# ROADWAY AND STORM SEWER CONSTRUCTION PLANS FALCON MEADOWS AT BENT GRASS FILING NO. 4 FALCON, CO 80831 - EL PASO COUNTY CHALLENGER COMMUNITIES, LLC

$\sim$ PCD-ENGINEERING REVIEW COMMENTS IN BLUE BOXES WITH BLUE TEXT

# Construction Drawings (PlansProfiles)\_v1.pdf Markup Summary 8-29-2022

**OVERALL SHEET**

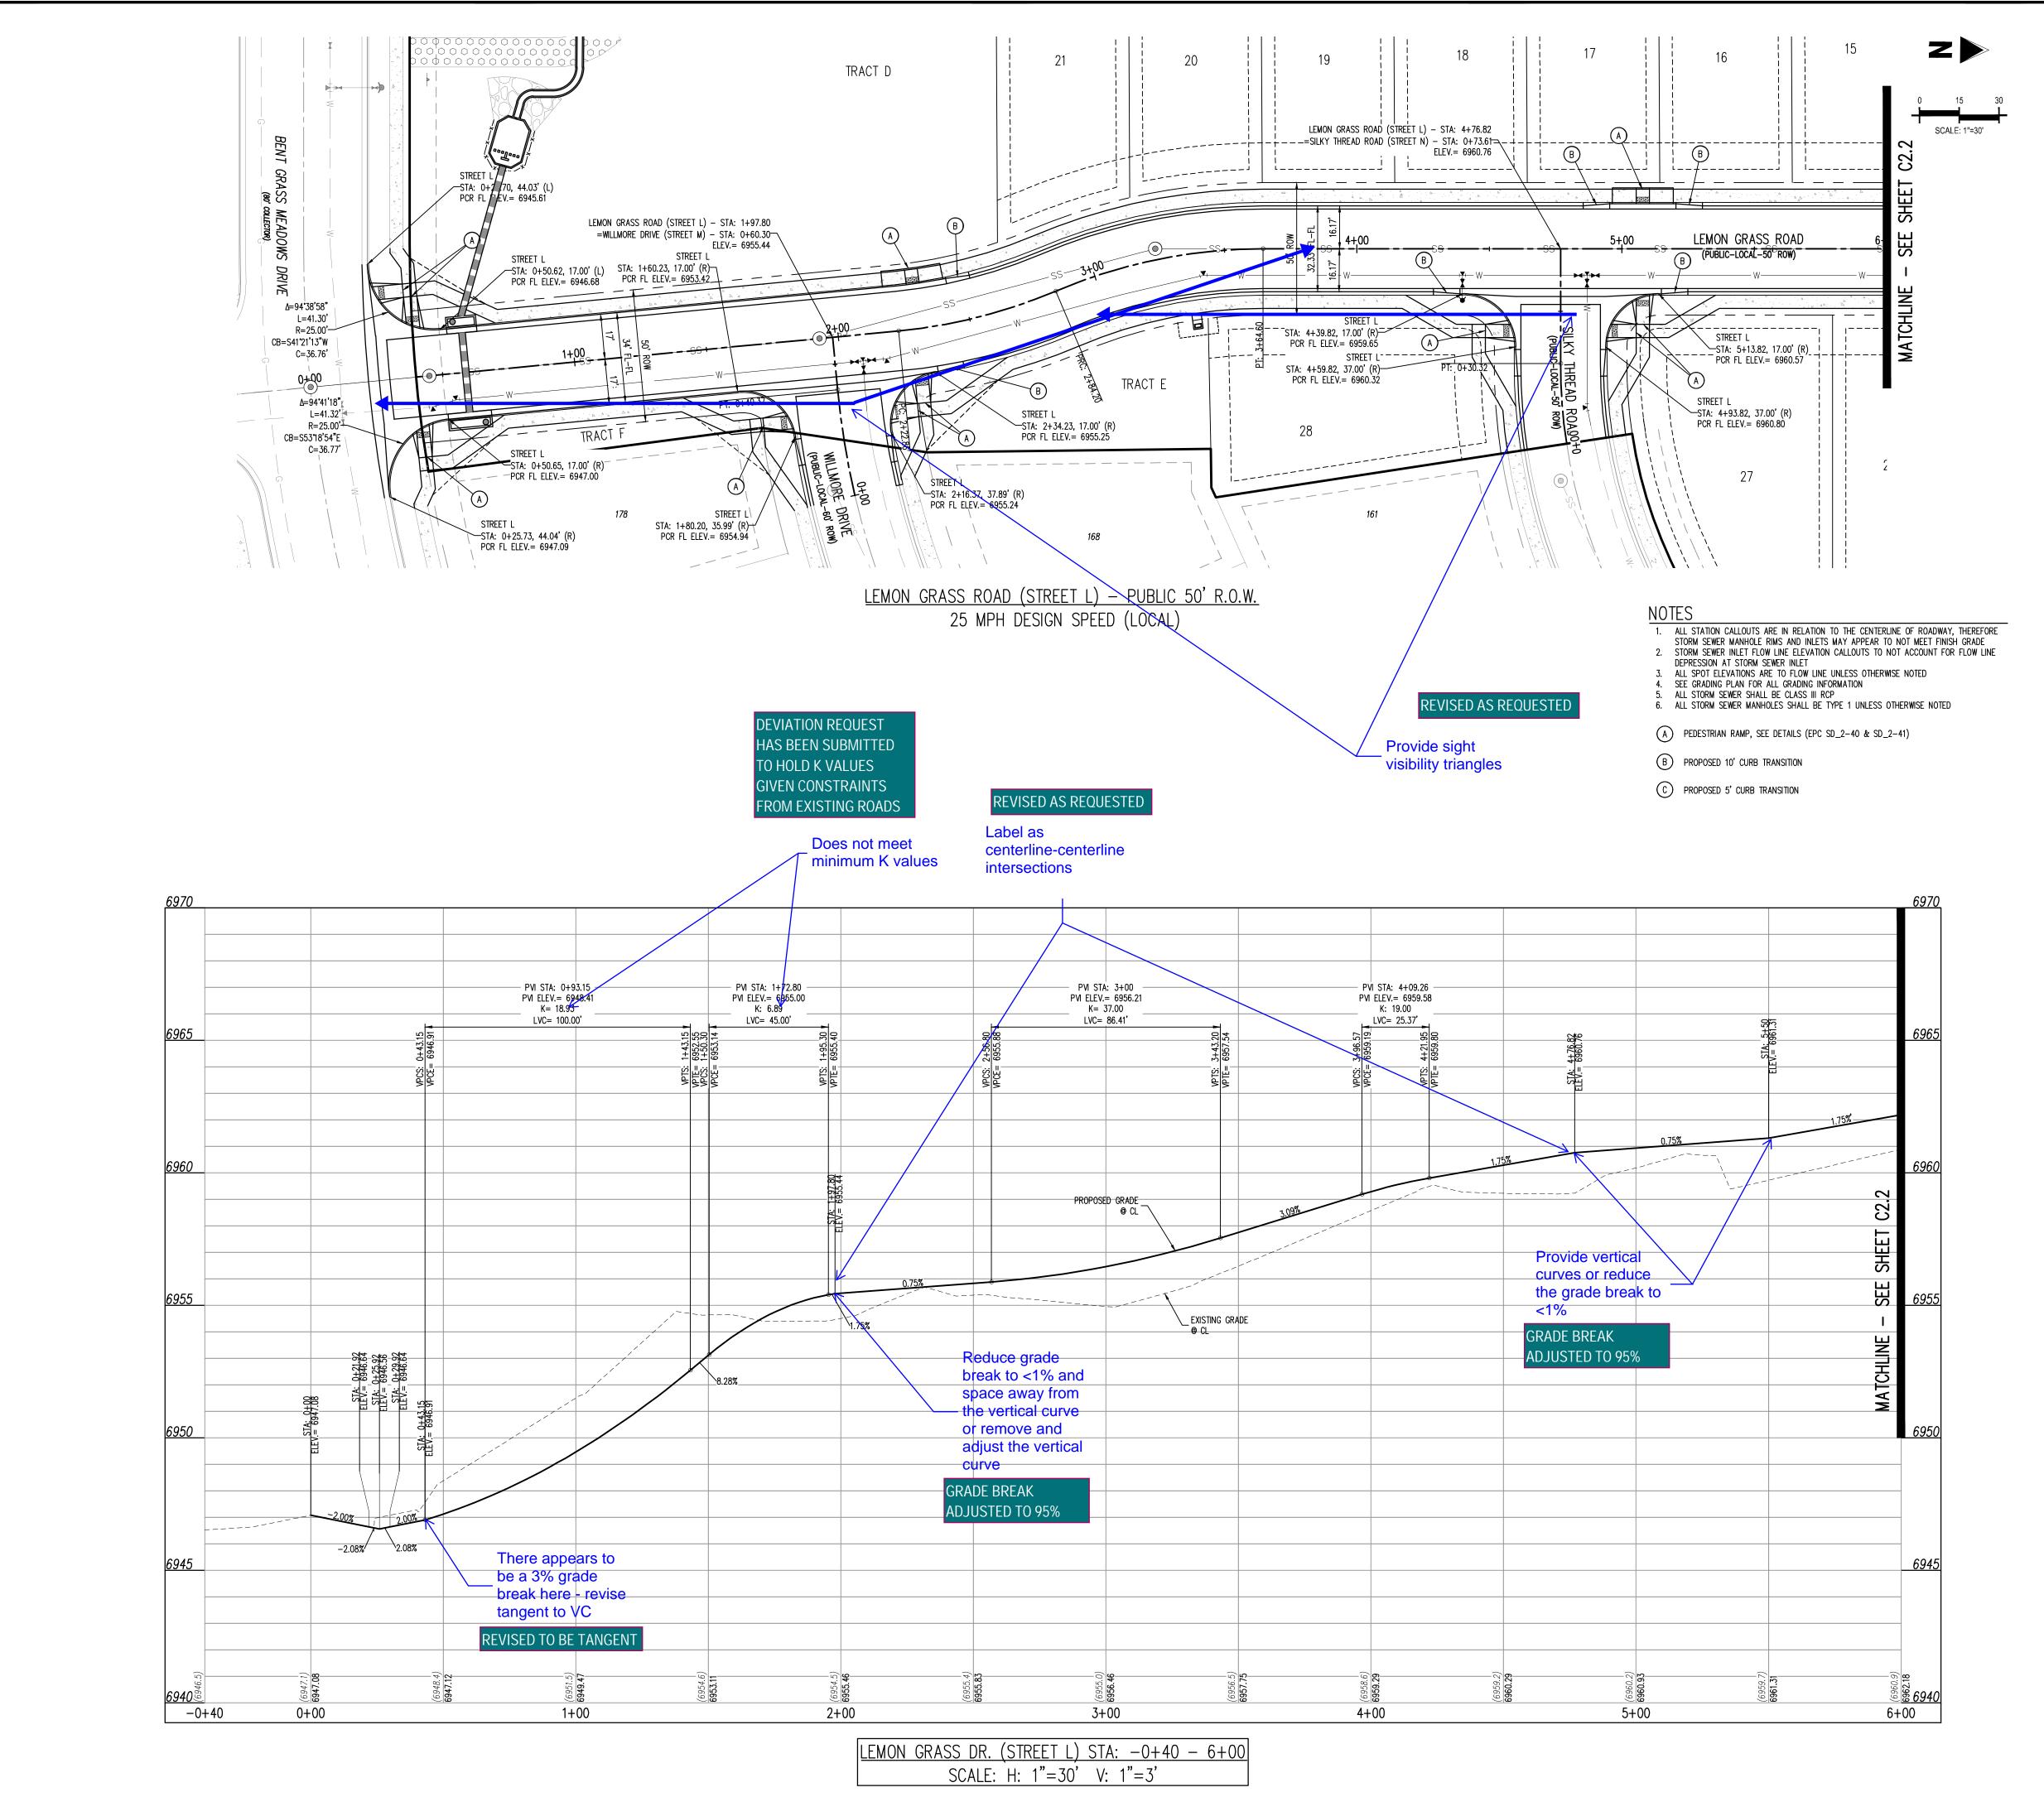
Adjust/add tracts per other comments

LEMON GRASS RD IMPROVEMENT PLAN

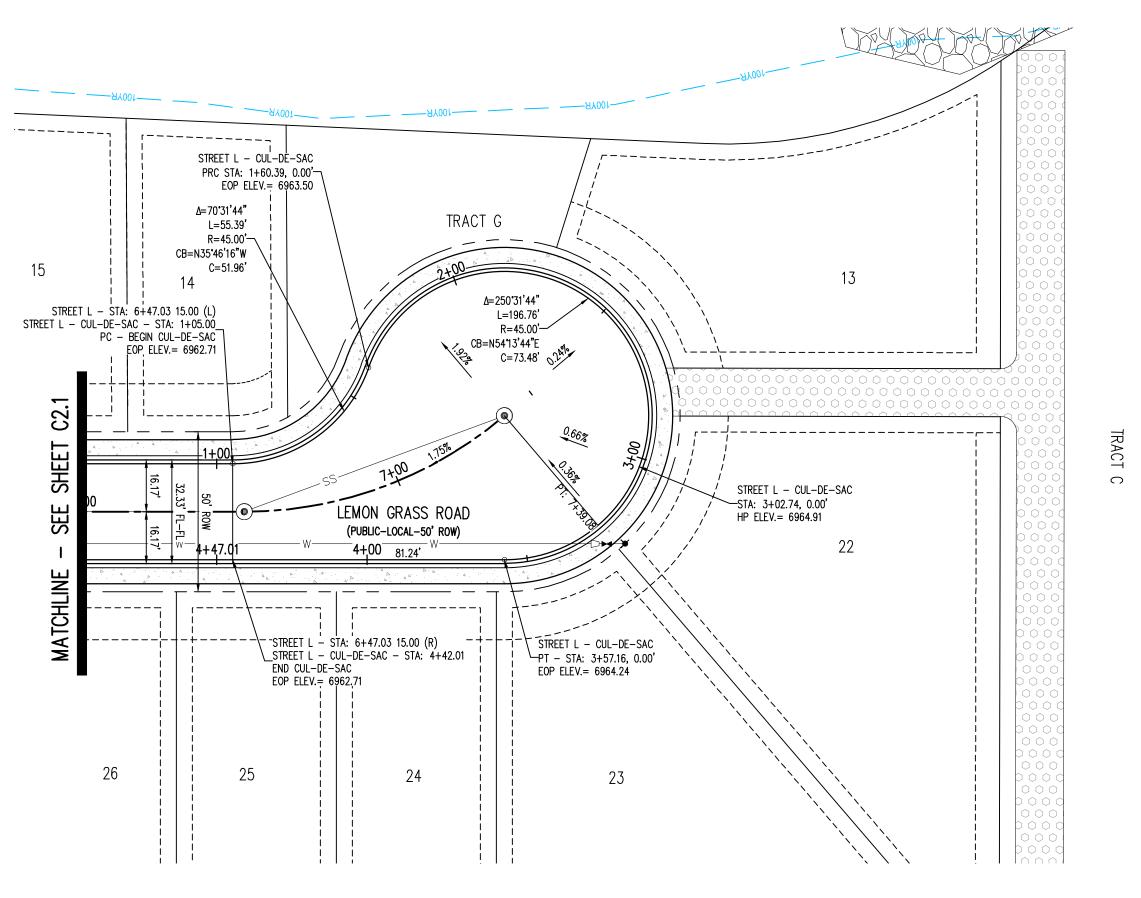
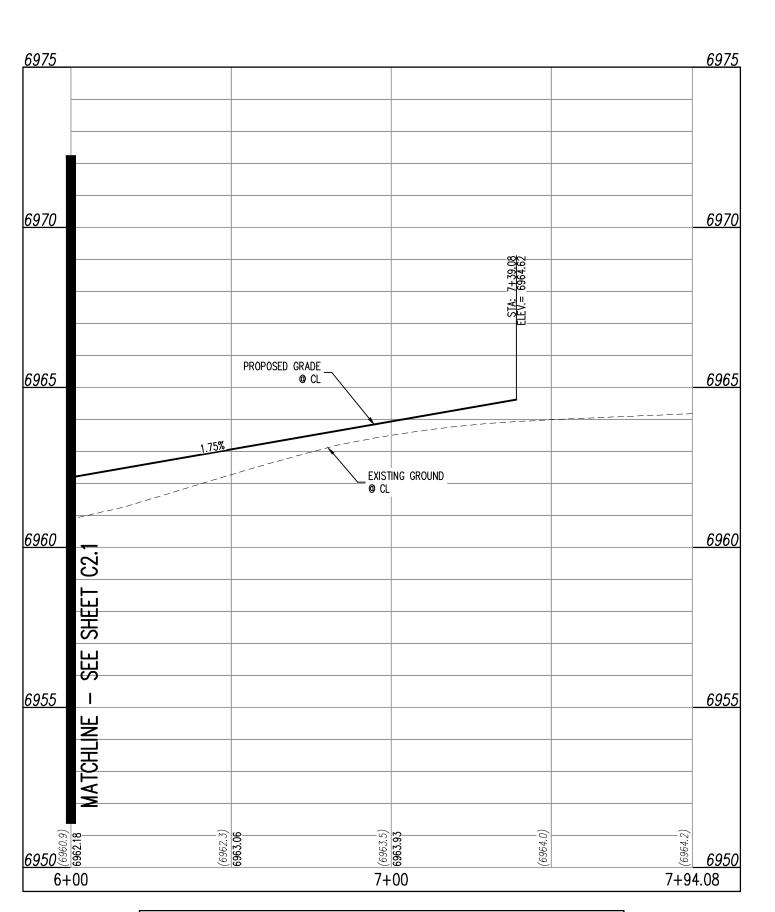
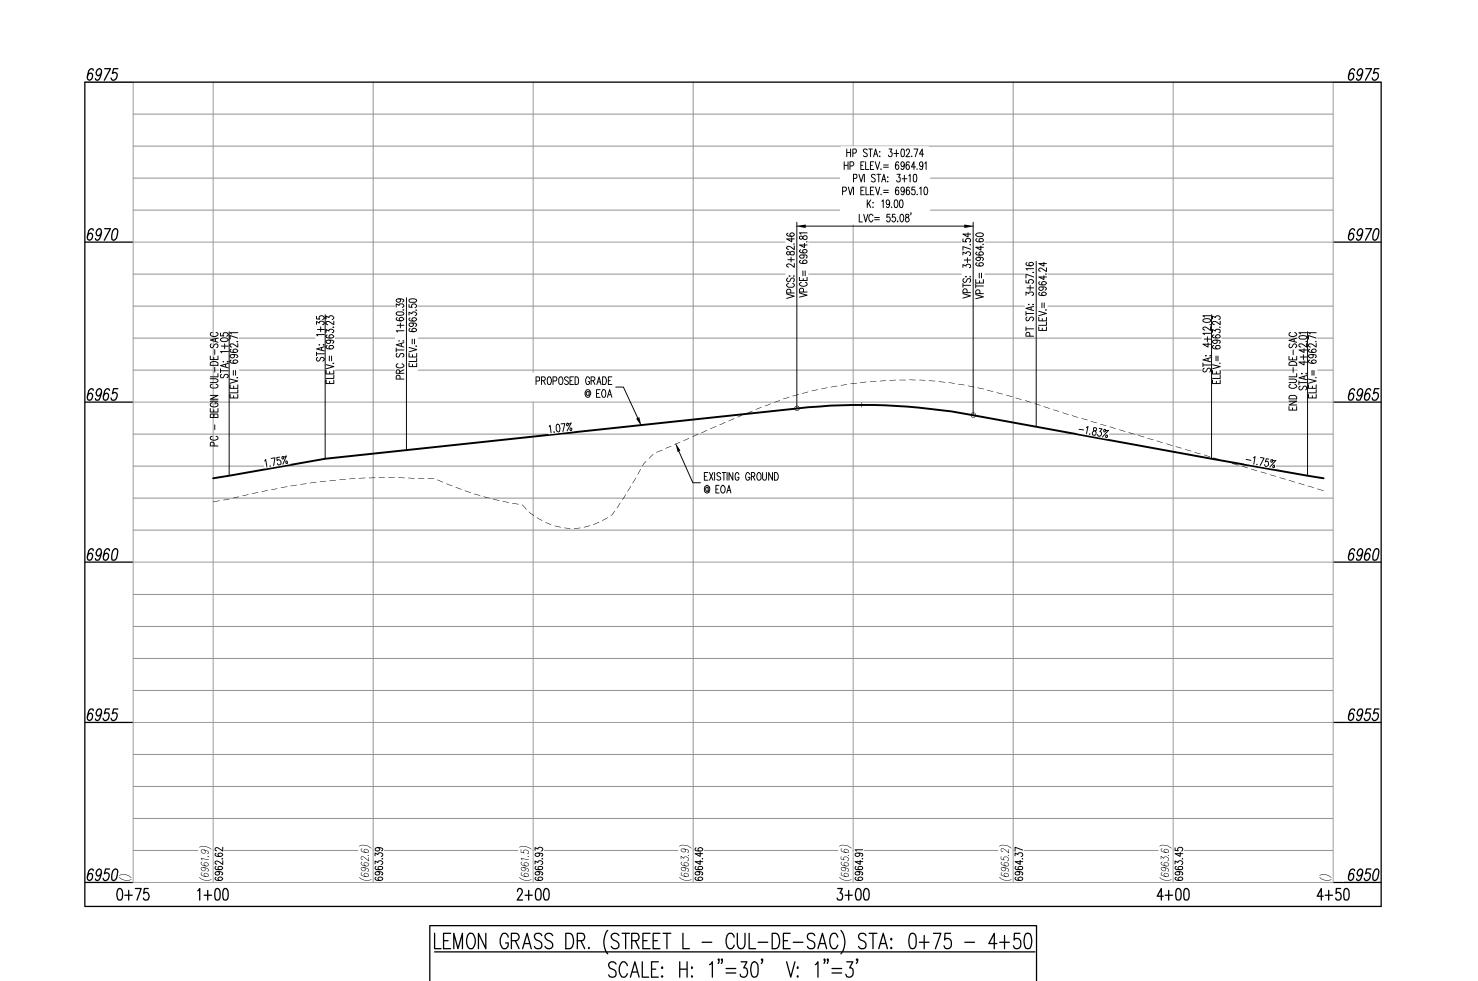
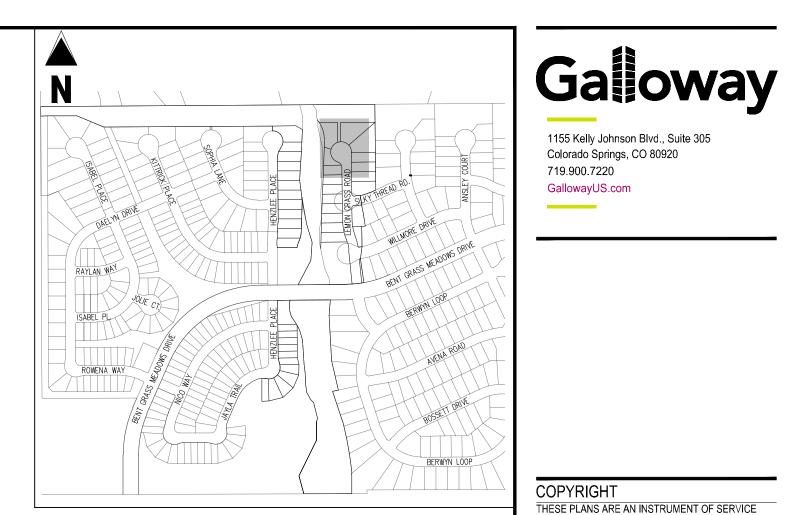
Page Label: [5] 5 LEMON GRASS RD IMPROVEMENT PLAN There appears to be a 3% grade break here -

Reduce grade break to <1% and space away from the vertical curve or remove and adjust the vertical

revise tangent to VC

Page Label: [5] 5 LEMON GRASS RD IMPROVEMENT PLAN Provide vertical curves or reduce the grade break

Page Label: [5] 5 LEMON GRASS RD IMPROVEMENT PLAN Does not meet minimum K values

Page Label: [5] 5 LEMON GRASS RD IMPROVEMENT PLAN Provide sight visibility triangles

Page Label: [5] 5 LEMON GRASS RD IMPROVEMENT PLAN Label as centerline-centerline intersections
